**HADITHA DAM PERIMETER SECURITY
HADITHA, IRAQ**

SUSTAINMENT ASSESSMENT

**SIGIR PA-09-192
APRIL 13, 2010**

SUBJECT: Report on the Haditha Dam Perimeter Security, Haditha, Iraq (SIGIR Report
Number PA-09-192)

Figure 2. Contractor's design of typical fence section
(Courtesy of GRC)

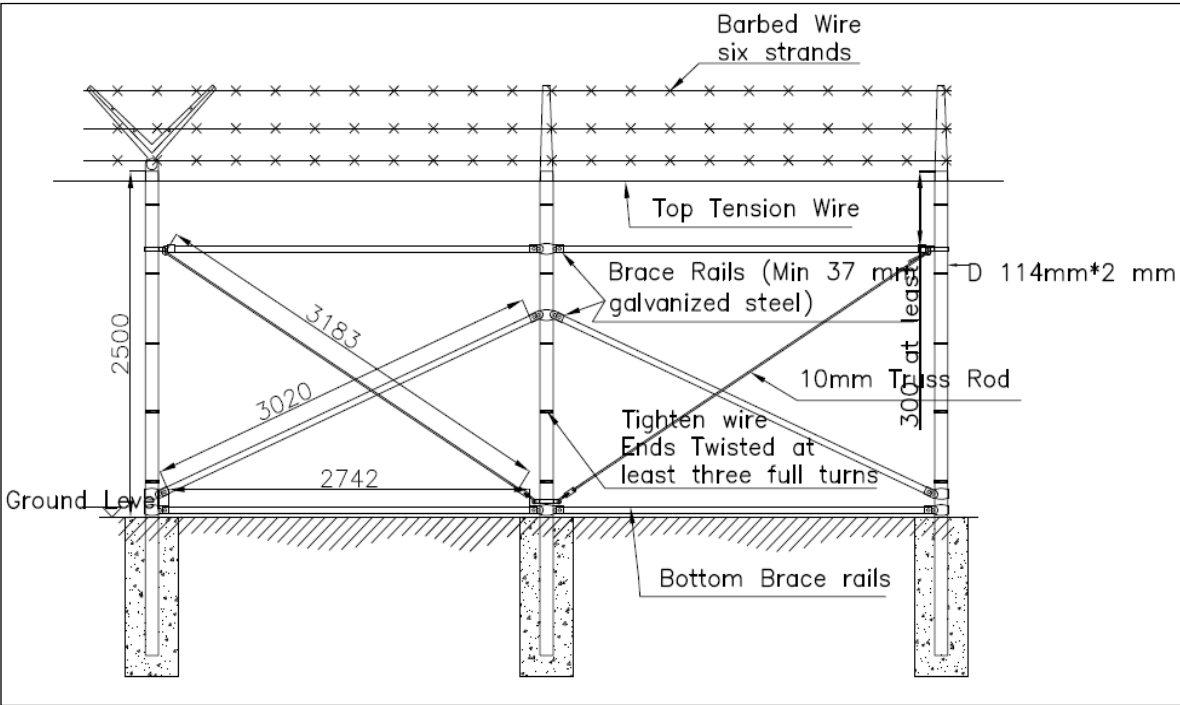
The contractor attached the chain link fabric to the fence posts with steel bands at 32 inches on center. The attachment did not conform to the 15 inches on-center requirement of the USACE standard drawings for a security fence, and was not consistent with the 18 inches on-center indicated on the contractor’s drawings.

The fence brace rails were different dimensions than shown on the contractor’s drawings. The brace rails were attached to the pull post approximately 36 inches above the post base, instead of 58 inches as shown on the contractor’s drawings. The difference will affect the ability of the brace panel to resist tension from the chain link fabric.

The concrete anchorage for the fence posts was approximately 8 to 12 inches deep (Site Photo 6), which was inconsistent with the contractor's design drawings that showed a 45 inch depth for a typical line post. The configuration of the concrete anchorage was not consistent with the contractor's design plans and tapered from approximately 16 inches in diameter at the top to 8 inches in diameter at the base of the post, instead of the required uniform diameter of 16 inches. In addition, the anchorage did not cover the end of the post as shown in the design drawings, which will allow for increased corrosion of the post.

Site Photo 8. Poorly constructed swale crossing

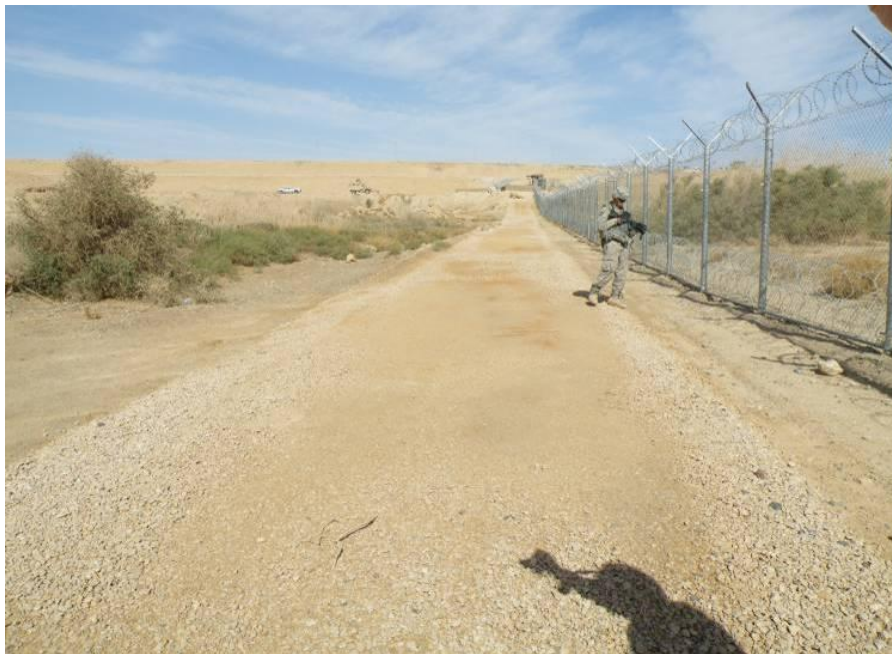
While inspecting the collapsed section of the fence, SIGIR noted a poorly constructed swale⁷ crossing (Site Photo 8). To bridge an existing swale perpendicular to the fence line, the contractor extended the spacing between posts and extended the chain link fence

across the swale. This left a gap several feet high and several feet wide beneath the chain link fence. The concertina wire placed at the base of the fence did conform to the contour of the channel and provides a less effective barrier to prevent entry to the facility.

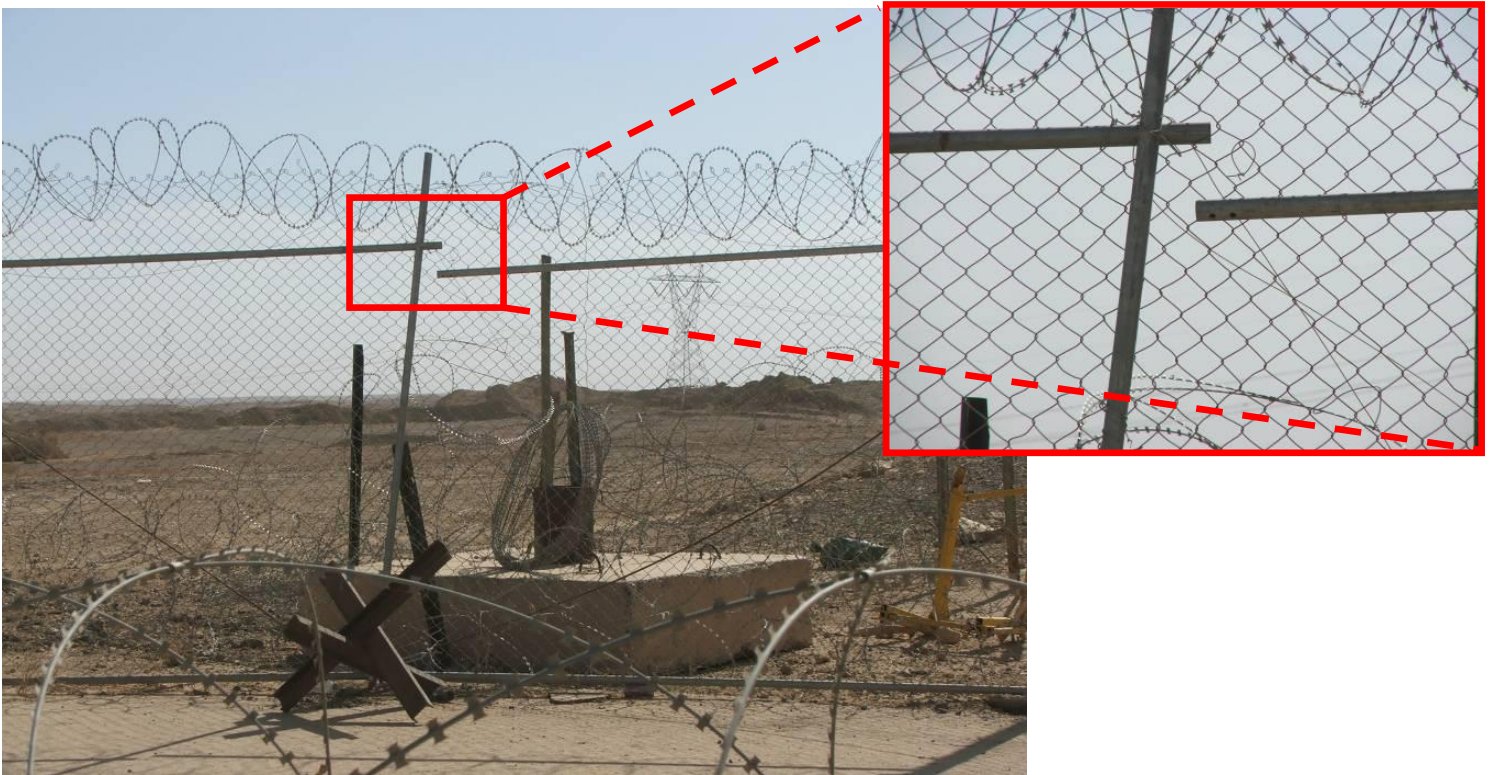
The entry point was constructed completely opposite of the contractor's submitted design plans. The contractor's plans indicated a reasonable method of controlling entry to the facility by using "Jersey" barriers and a lifting gate to slow vehicles prior to reaching the security fence. However, as constructed, vehicles first reach the swing gate in the security fence. After entering the secure area, vehicles are then confronted with the lifting gate, and finally directed through the chicanes into the facility. This configuration contributes little to force protection and allows vehicles to approach the secure area without any method to control speed or direction.

SIGIR noted that the quality of construction of the entry gate was poor. The swing panels of the gate were misaligned and the swing posts were not plumb (Site Photo 11).
